# AKM Knit Wear Ltd

14 Gedda, Karnapara, Ulail, Savar, Dhaka 1340  
(23.82743N, 90.25867E)

# Observations

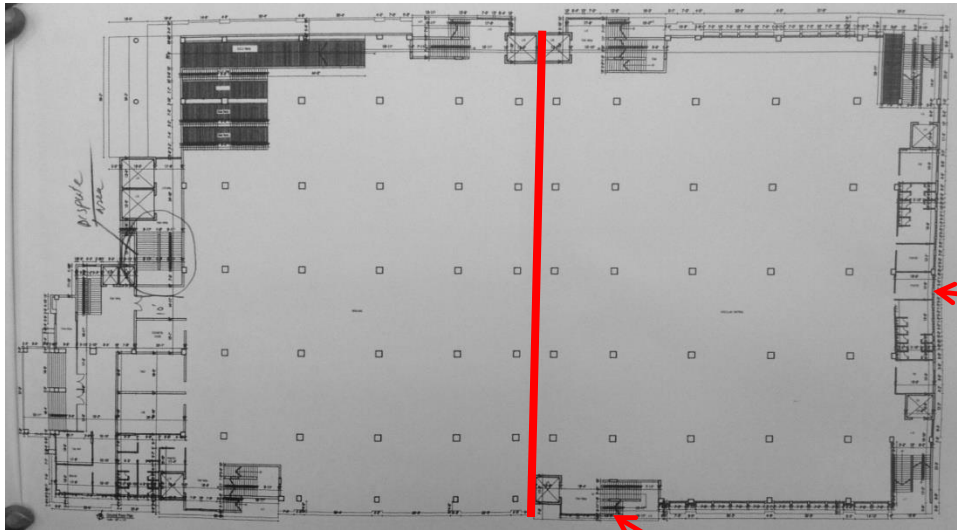
We note that loading plans have been produced and a loading manager has been appointed. We do feel, however, that the allowable loads contained in this document are too high. Engineer to review this paying attention to stresses in columns at basement floor.

# Facade Cracking

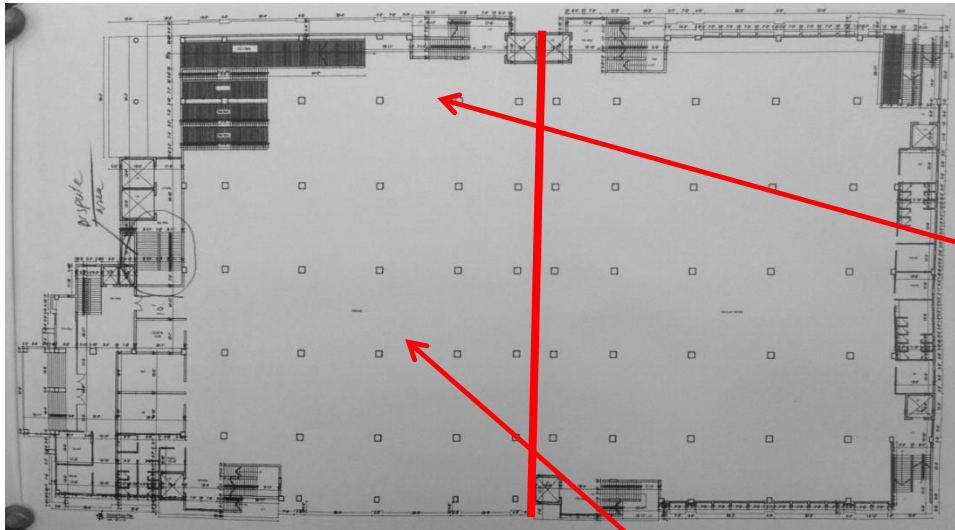
Cracking was observed in the façade brick-work over the cantilevers. Building Engineer to monitor.

## Drop Pad & Slab cracks

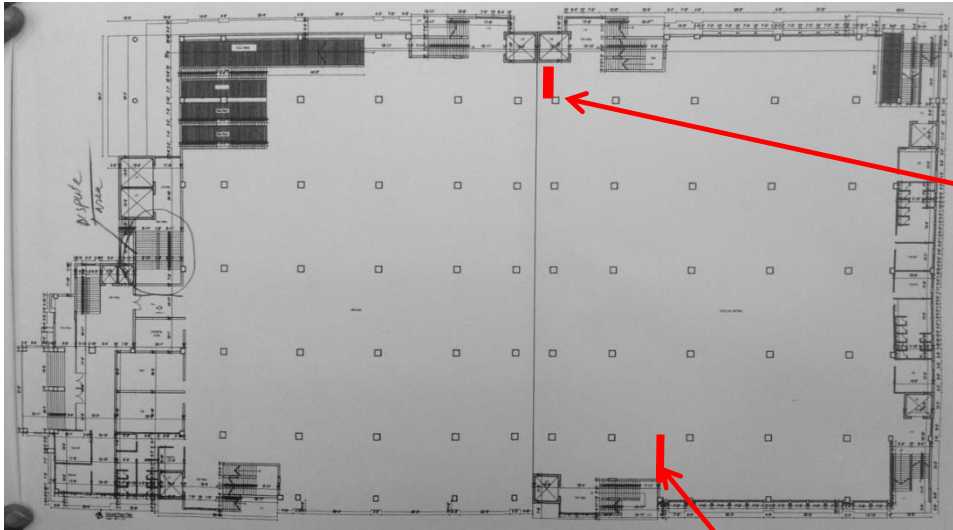
**There was evidence that the render to drop pad & slab was cracked in a number of locations. Render to be removed to ensure cracks do not extend in to the structure. Building Engineer to monitor.**

## Beam cracks

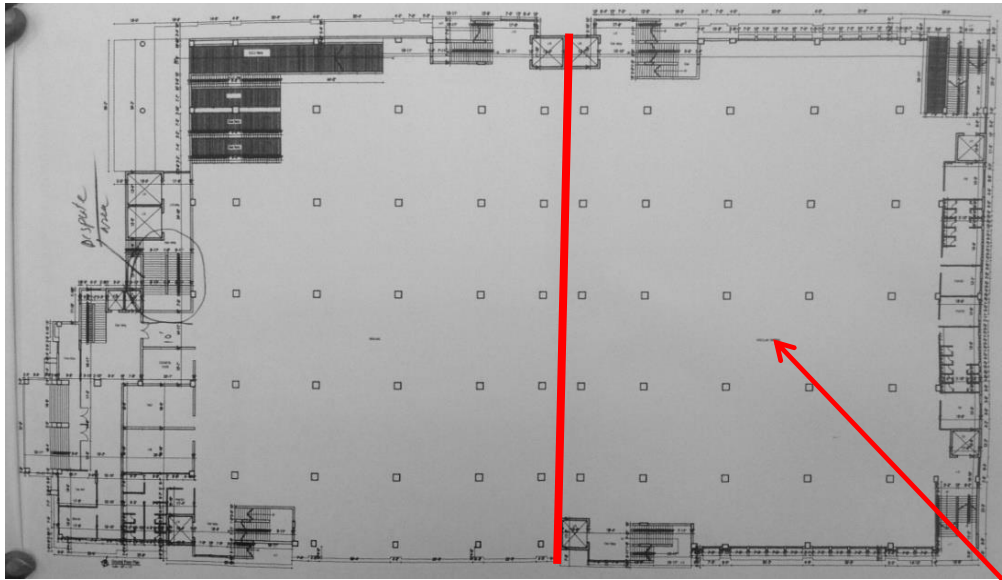
Cracking was observed in a number of beams. Render to be removed to ensure cracks do not extend in to the structure. Building Engineer to monitor.

## Water ingress

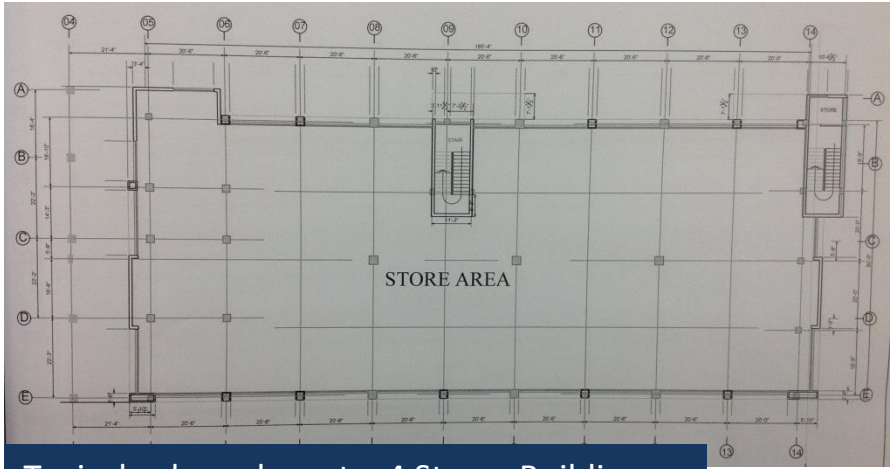
There was evidence of water ingress into structural elements. Building Engineer to monitor.

# **Accessories & Utility Building - Columns appear to be stressed in excess of normal design limits**

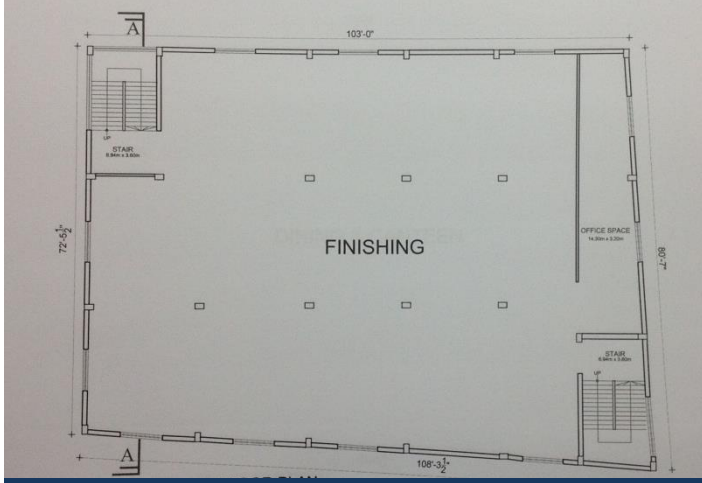
Cursory calculations indicate column working stress is in excess of normal design limits.

Building Engineer is to perform detailed calculations and concrete tests to prove column size and (if required):

- Reduce loads by vacating floors
- Reinforce columns

## **Steel Infill Slab**

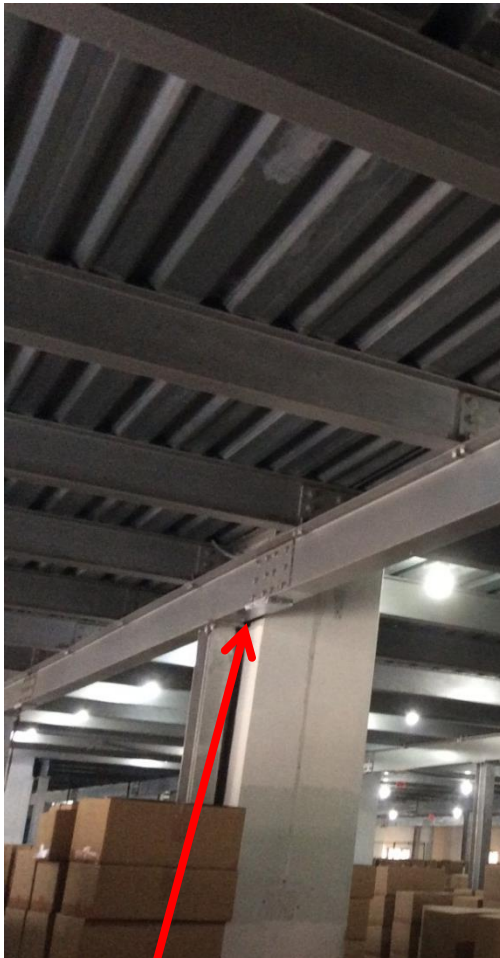
**Note: Steel infill not shown on Permit Drawings.**

**Engineer to confirm steel infill floor connections to façade are sound and how steel floor is connected to the main concrete structure.**

**Engineer to confirm all connections are adequate.**

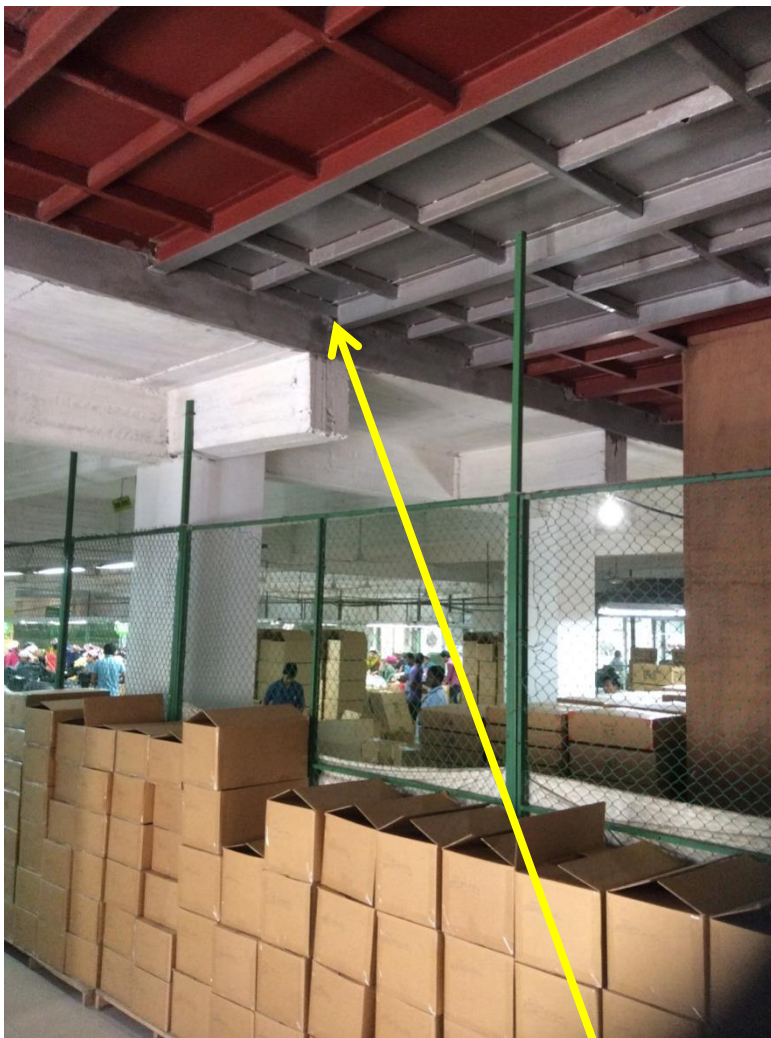
**Steel columns connected to First floor slab. Engineer to confirm capacity of slab to take additional loading.**

**Steel columns out of plumb. Engineer to confirm Stability of structure.**

**Building Engineer to confirm how steel beams are supported at walls.**

**Building Engineer to confirm adequacy of connection of steel infill slab to concrete structure either side.**

Engineer to confirm connection of steel structure to water tank slab and to check slenderness of column.

**Accessories Building - Stability of steel  
roof to dining area to be reviewed by  
Building Engineer**

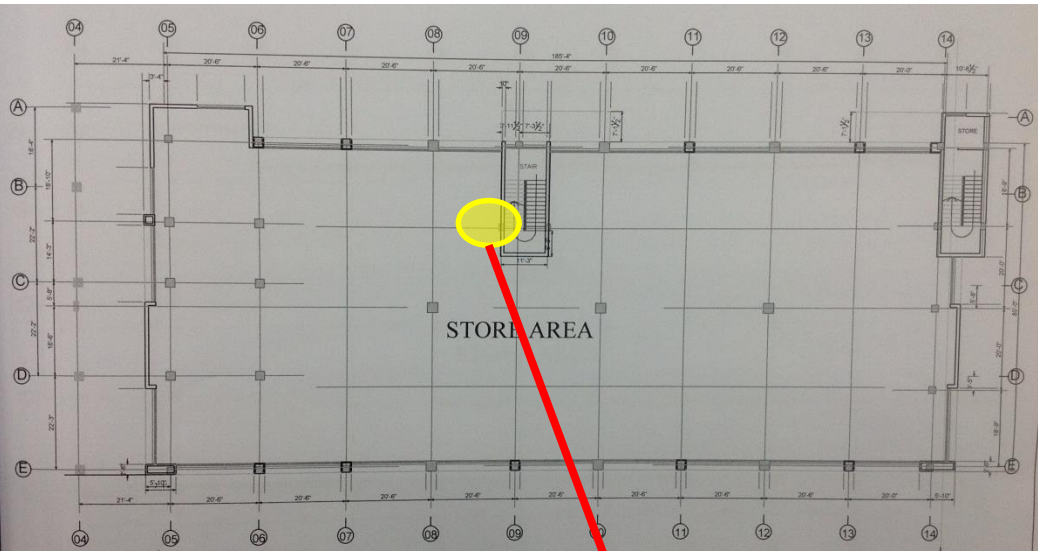
**Roof structure to Dining Area, may be susceptible to wind uplift.  
Building Engineer to review.**

Building Engineer to confirm support/connection detail at these locations.

# Utility Building - Concrete connections

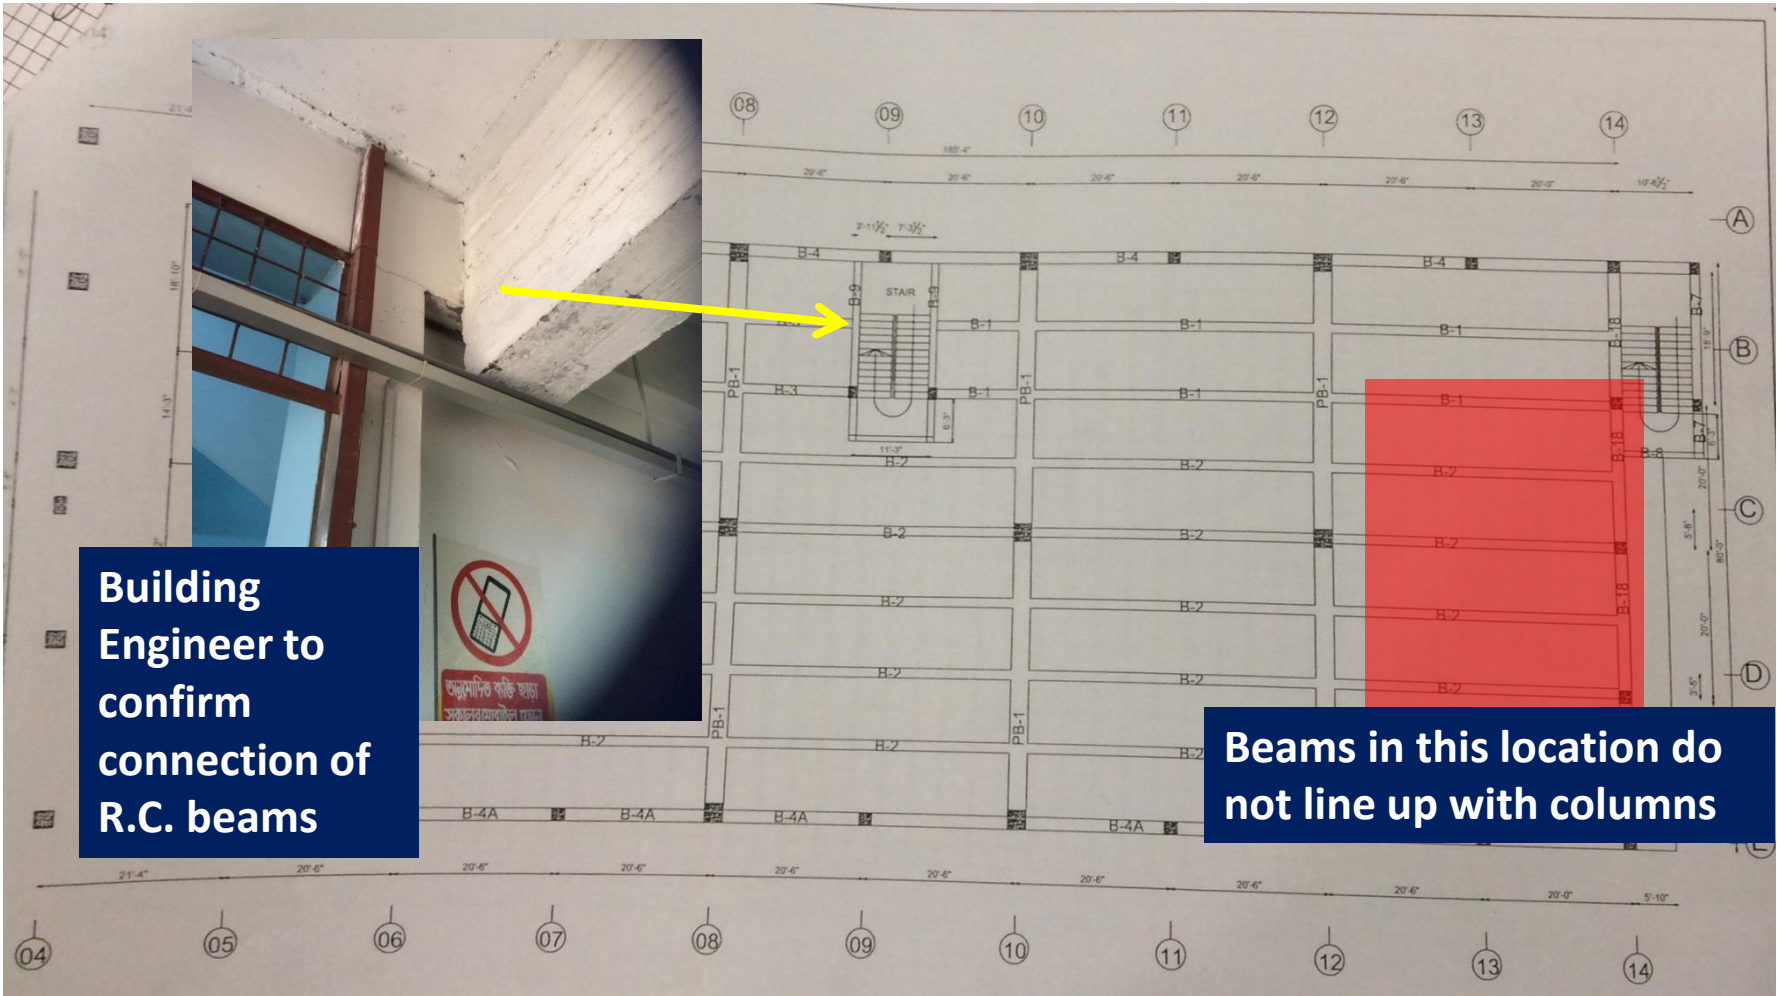
**Building Engineer to confirm connection of R.C. beams**

**Building Engineer to confirm connection of R.C. beams**

**Beams in this location do not line up with columns**

**Beam layout does not match as constructed layout. Some beams do not line up with columns. Engineer to confirm that the as built structure matches the design intent for beams and columns.**

# Concrete connections in Utility Building

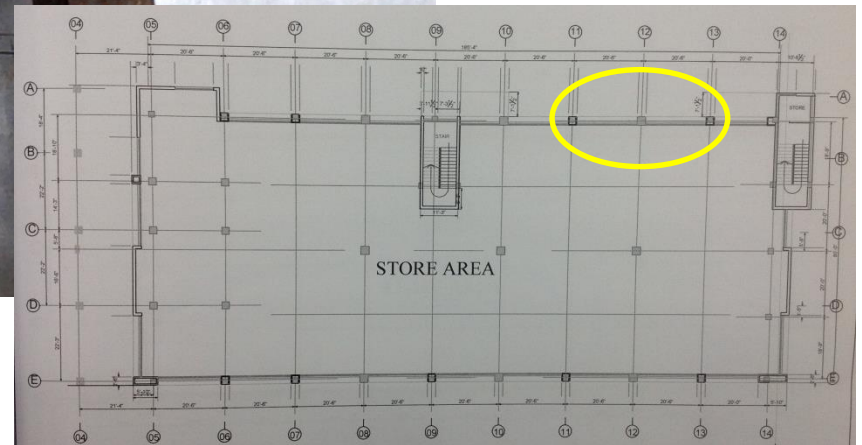
Engineer to confirm that concrete structure matches design intent.

# Steel Structures

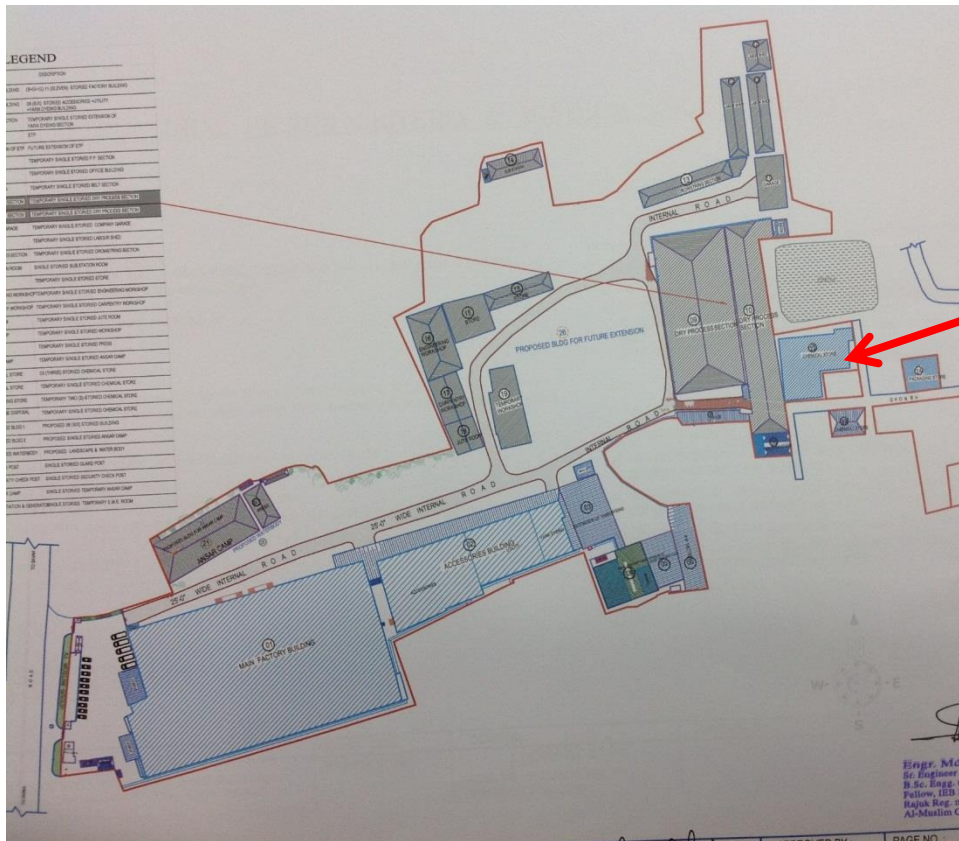
Engineer to review adequacy of structure to carry water tank

Façade of Chemical Store is tack welded to top of column.

Bracing details not evident in several locations – Engineer to review

Connection Detail unknown

Engineer to review stability and connection details on all steel structures.

# Lightweight Steel Canopy – Adjacent to Utility Building

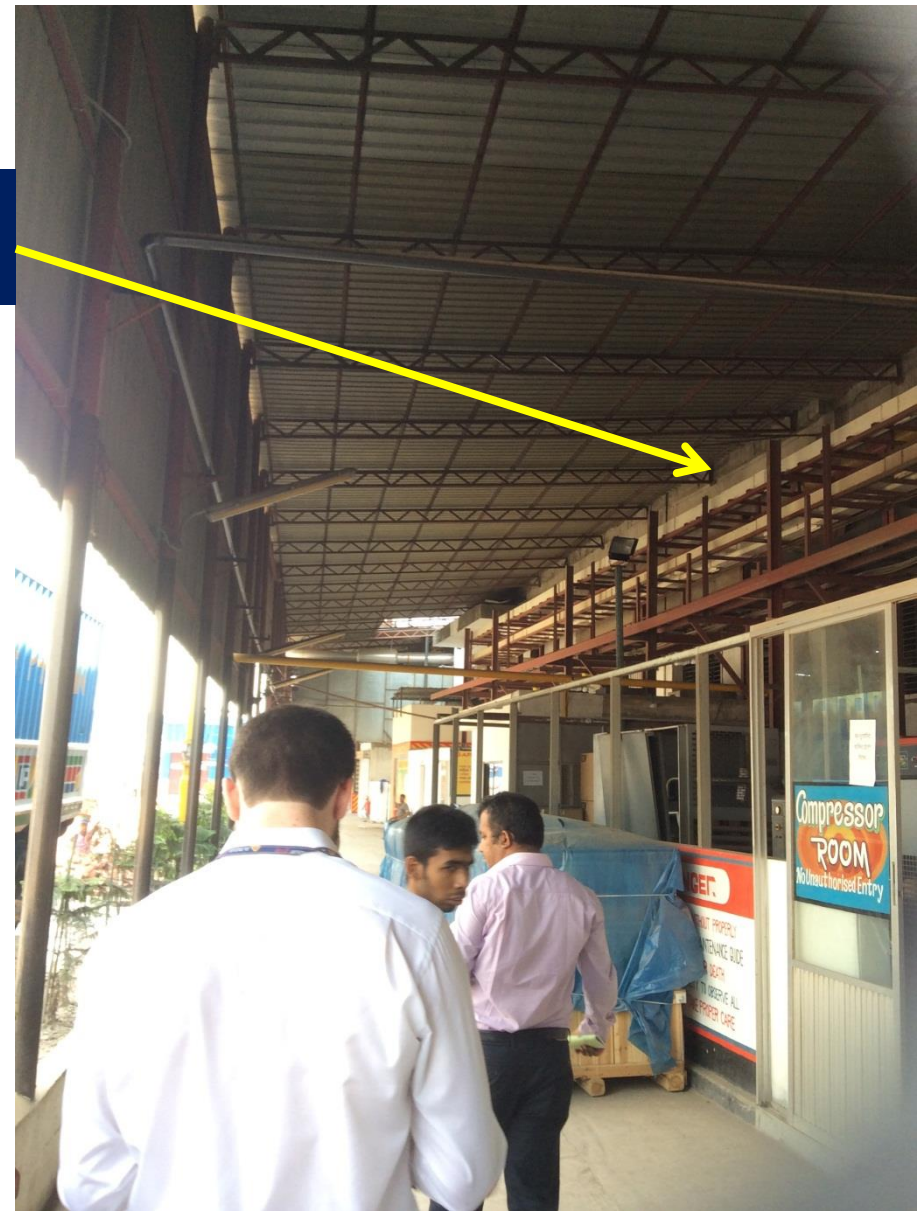
Engineer to assess stability and connections of lightweight steel canopy.
